<i>Project Name:</i>	Sugar Creek
<i>Proponent/Owner:</i>	Ben Steele / Rivergate LLC
<i>Project Address:</i>	Approximately 1095 West 600 South
<i>Request:</i>	Rezone from NR-4 to MR-9 & 210 Lot Subdivision
<i>Current Zoning:</i>	Suburban Neighborhood Residential NR-4
<i>Date of Hearing:</i>	March 23 <sup>rd</sup> 2023
<i>Type of Action:</i>	Legislative & Quasi-Judicial
<i>Submitted By:</i>	Russ Holley, Senior Planner

Staff recommends that the Planning Commission **deny** a Rezone and Subdivision Permit for project PC 23-018 Sugar Creek, located on approximately 35.48 acres at approximately 1095 West 600 South; TIN #02-066-0030; -0031; -0019; -0021.

SUGAR CREEK SUBDIVISION  
PRELIMINARY PLAT

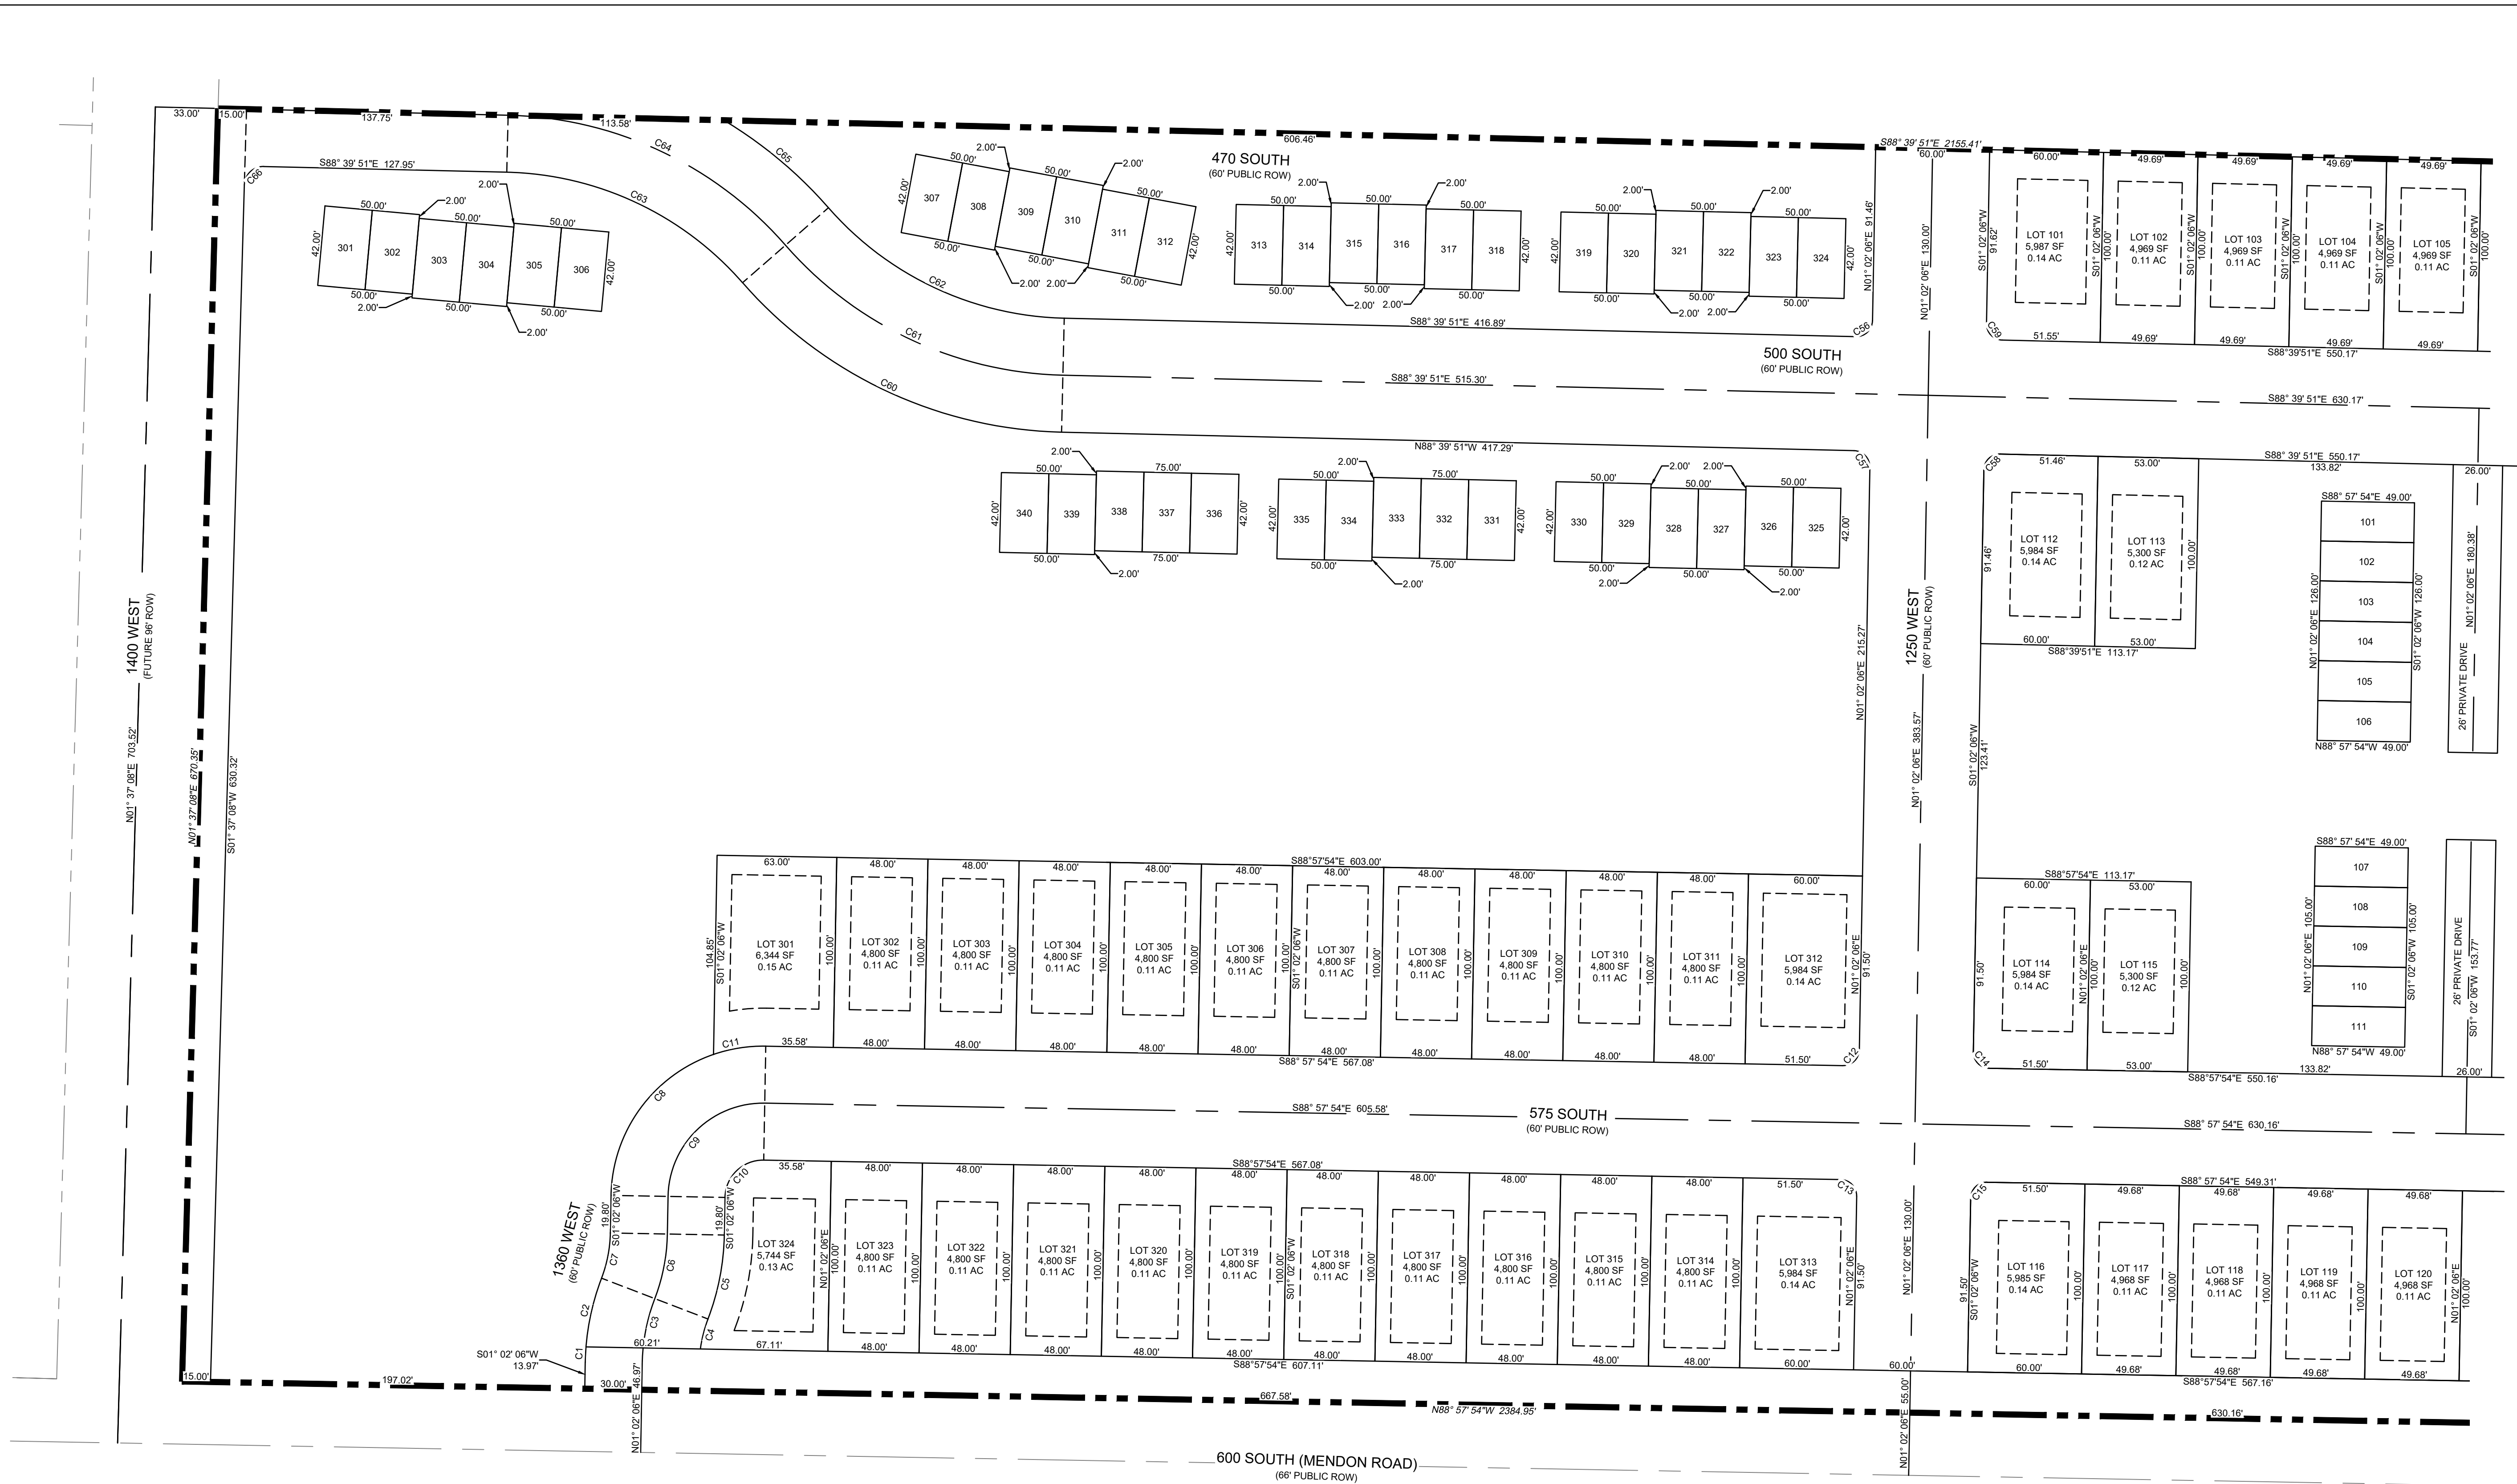
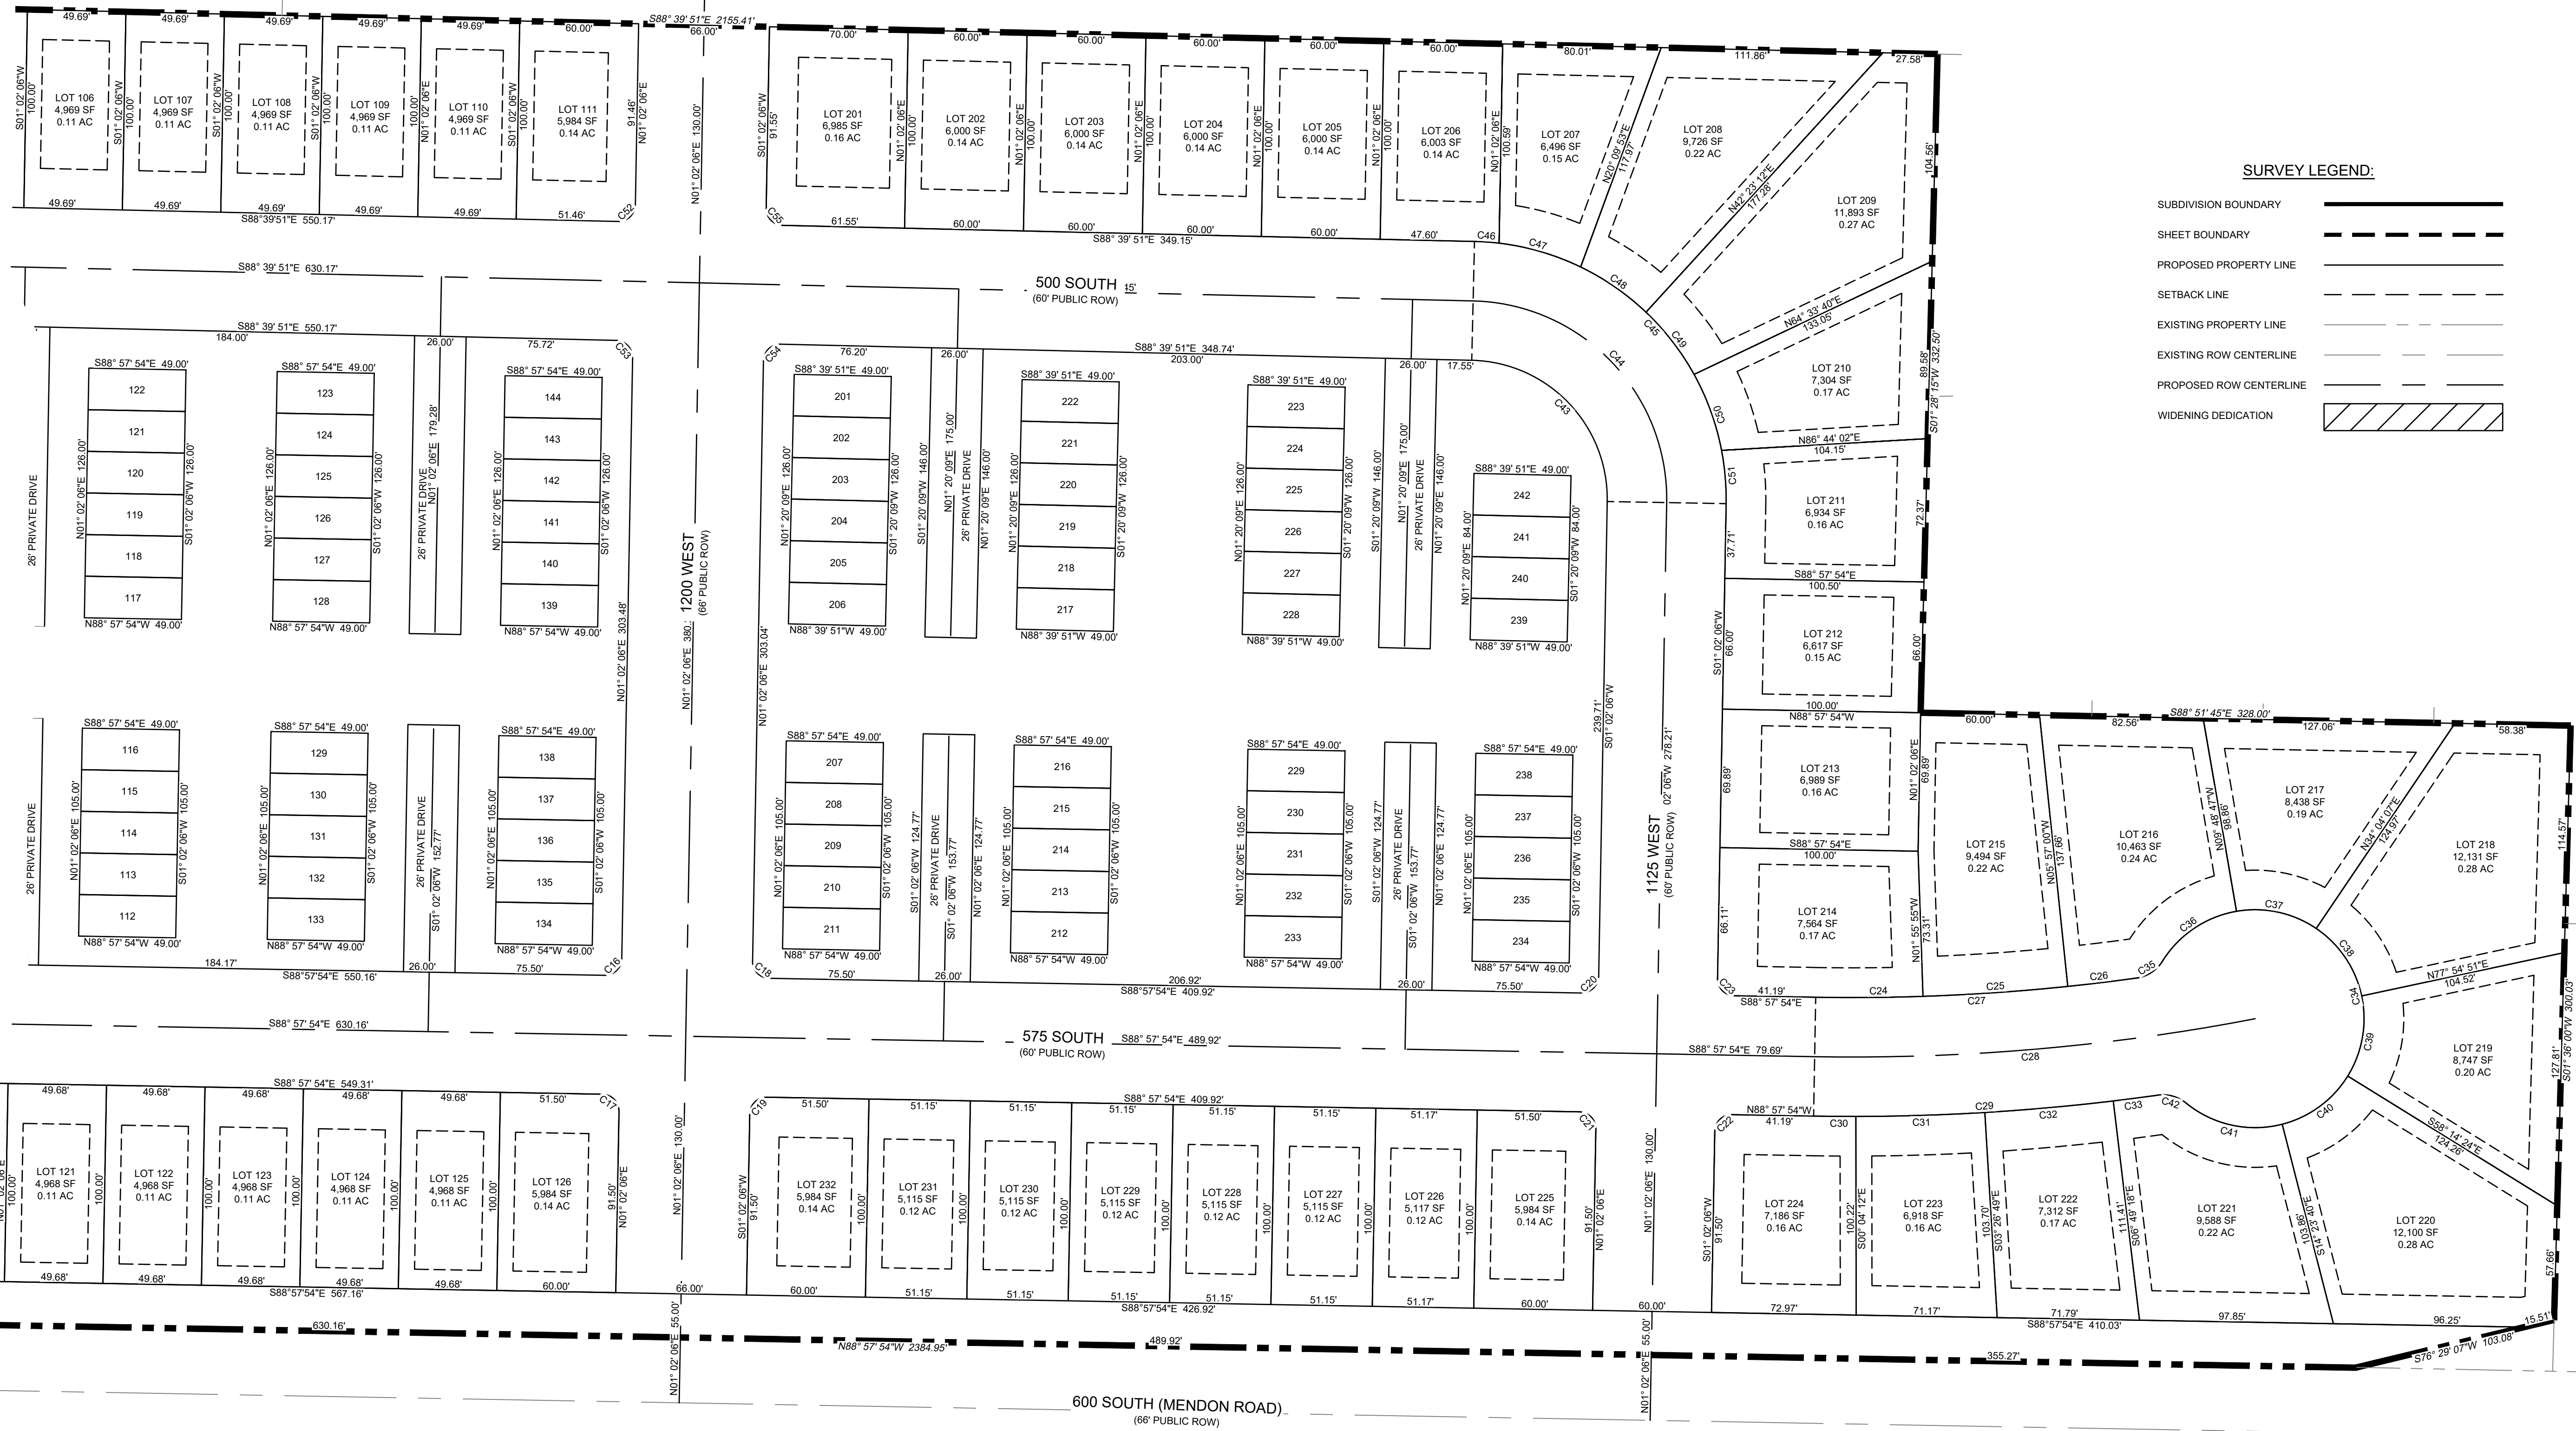
The LDC 17.30.190 requires projects serving fifty-one (51) or more dwelling units have at least three (3) street connections or stubs for future connections unless adjustments are warranted as per LDC 17.30.170.D. The LDC street connectivity requirements also require the continuation of residential block patterns to adequately connect to surrounding areas based on context and existing conditions. These requirements ensure equitable traffic distribution, efficient utility/infrastructure networks, better walkability and the continuation of Logan City’s historic grid/block patterns. This proposal includes seven (7) new street connections (including street stubs), and the creation of several internal blocks for inner project connectivity. The block patterns align with existing developments to the north, south and east. Adjustments to street alignments are made near the wetland areas on the west side of the project to avoid unnecessary disturbance to those sensitive lands. As proposed, the project meets street layout and connection requirements in the LDC.

containing vehicle travel lanes, on-street parking, landscaping (park strip) and sidewalks are required. The proposed subdivision shows a 60-foot cross section throughout the interior areas of the project site with 66-foot cross sections for the gridded streets. The expansion of 600 South Street, as conditioned below by the City Engineer, will be a larger Collector category street and will have a wider “built” cross section at approximately 80 feet including buffering areas. As conditioned, the project meets the requirements in the LDC.

Townhome setbacks are conditioned with setback compliance with the above standards. For the single-family homes, setback compliance will be reviewed and approved on the above standards as each lot is individually proposed for construction. As conditioned, the project meets MR-9 setback compliance in the LDC.

- All of the sewer from the development needs to flow south to the existing lines in 600 S. Flowing north into 1200 W goes to a small lift station that shouldn't receive more flow.

- The proposed zone change will result in additional loading to the sewer collection system. This additional load will cause the existing sewer on Sundown Way to be over capacity and will have to be upsized from 8-inch to 10-inch. Logan City would prefer to construct a new 12-inch sewer main from Legend Dr. to 1580 W along 600 S. The Sugar Creek development would be expected to provide their proportional share of the cost to make these improvements. Coordinate with Public Works to determine the extent and cost sharing for upsized capacity.

- The plans submitted show storm water management improvements on the property, including the provision for storm water detention/retention basins. As a detailed report or study has not been reviewed, it is noted that additional pond area may be required to comply with the City's storm water management standards which may impact the plat.

- Stormwater basins shall not be located on residential lots. A dedicated parcel for stormwater management shall be provided and language added to the CC&Rs indicating that the storm water systems and ponds shall be maintained by the HOA.

- 600 South is identified as a minor arterial on the City's transportation master plan and as such requires a 102-foot right of way. Dedicate sufficient property to achieve a total (existing plus new) 84 feet of right of way as measured from the existing south right of way line along the entire length of the project. Prepare construction plans to build improvements associated with a modified collector street cross section. The north back of curb shall be located 24 feet south of the new north right of way line and the improvements shall include asphalt that ties into existing asphalt, curb & gutter, sidewalk, and park strip.

- 1400 W is designated as an arterial street on the City's Transportation Master Plan and as such will require 102 feet of total right of way that is in alignment with the existing preserved right of way to the south. As such, the eastern alignments of the rights of way shall match. Where the City will be constructing or participating in the construction of 1400 W to SR-30, the development will be required to construct the west half street improvements equal to the City's 80-foot collector road standard.

- Rename 470 S to 500 S and 500 S to 520 South.
- 1200 W and 500 S are gridded streets and as such shall have a total 66-foot dedicated width and shall be constructed to a gridded street cross section. A minimum of 20 feet of asphalt shall be constructed on any half street improvement.

## CIVIL PLAN

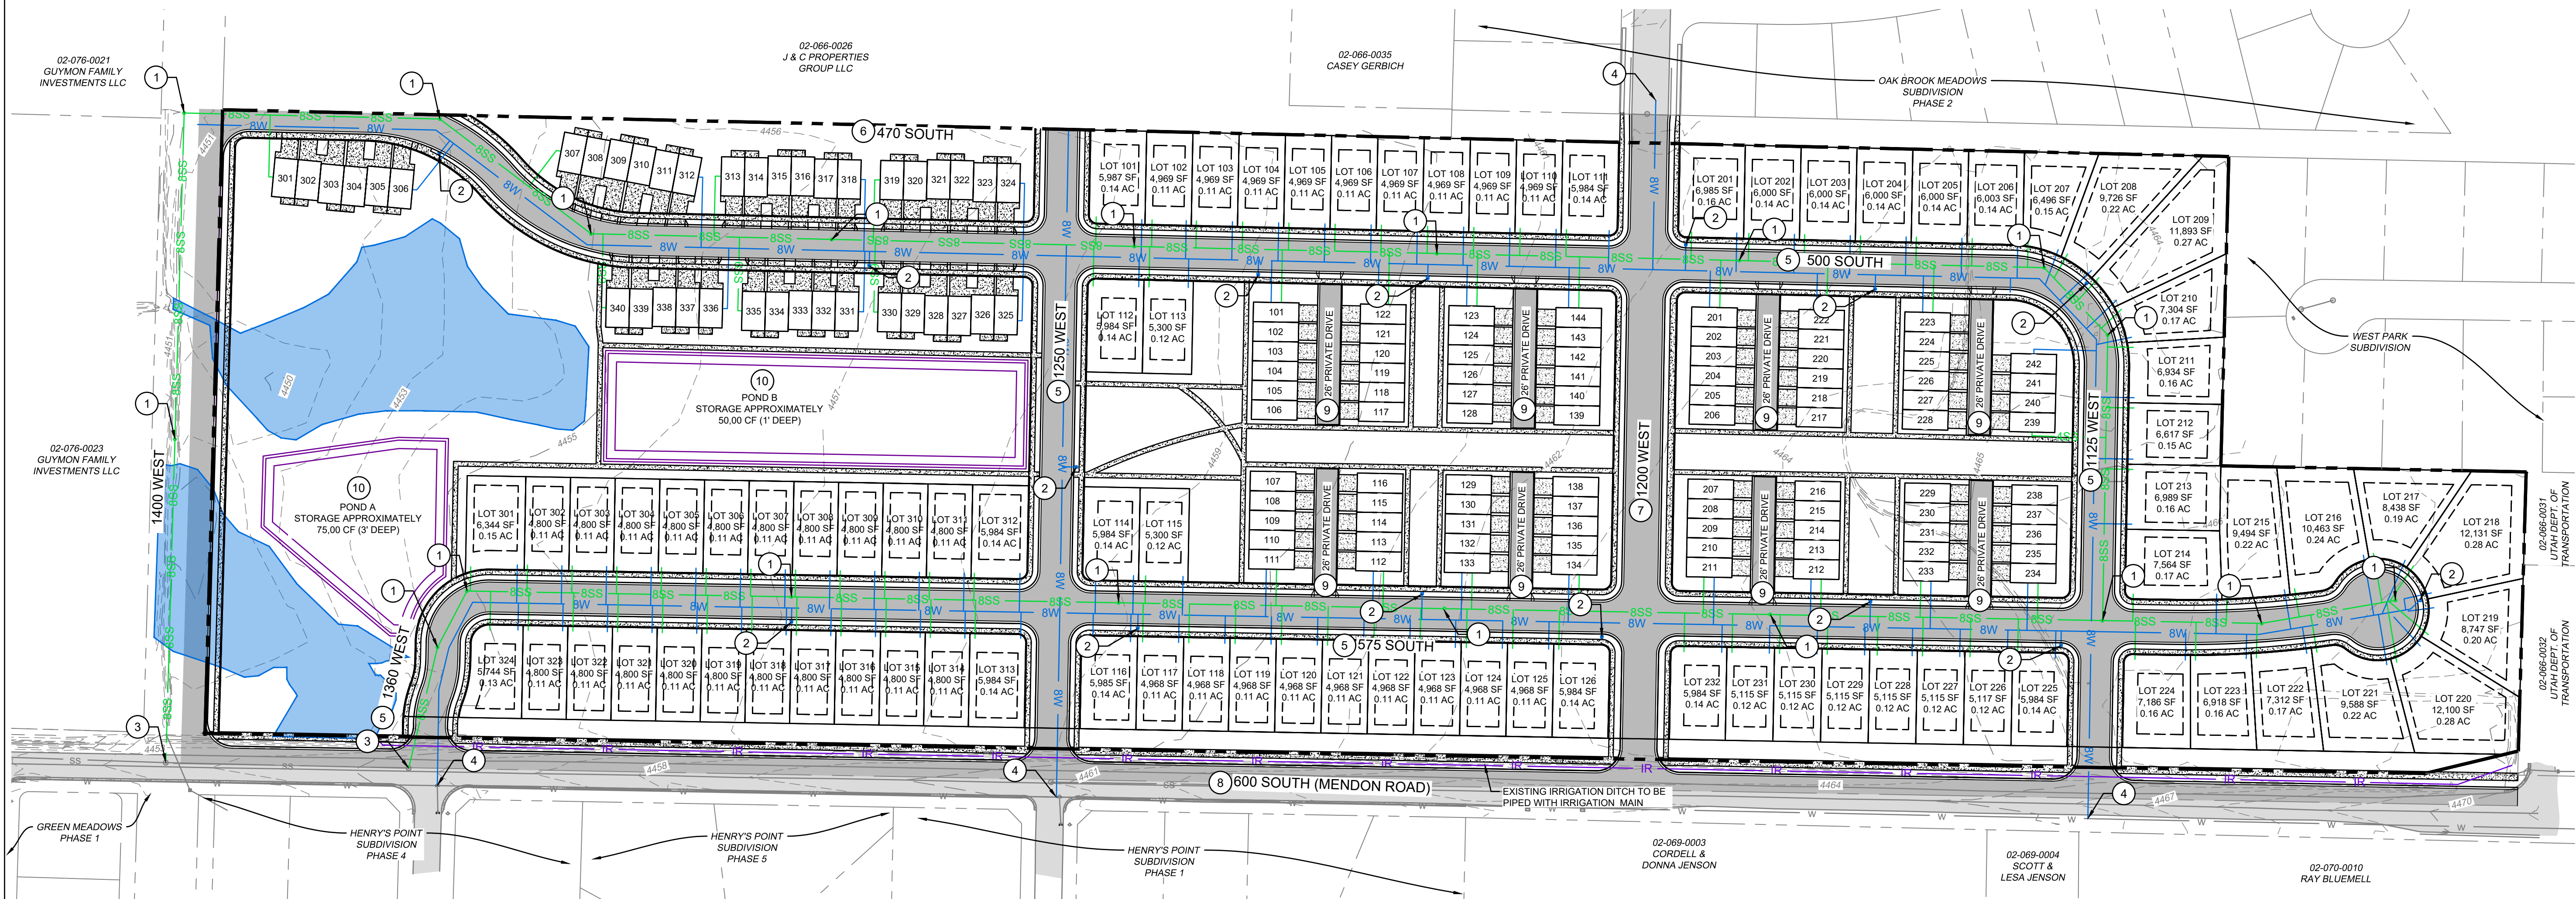
- Provide storm water detention/retention per Logan City Design standards. This includes the retention of stormwater from an adjacent existing streets that discharges to the property. Retention of the 90% storm event is required and shall be provided through the use of Low Impact design methods.

- The minimum diameter of storm drain piping in a City right of way shall be 15 inches unless a larger size is required by the design.
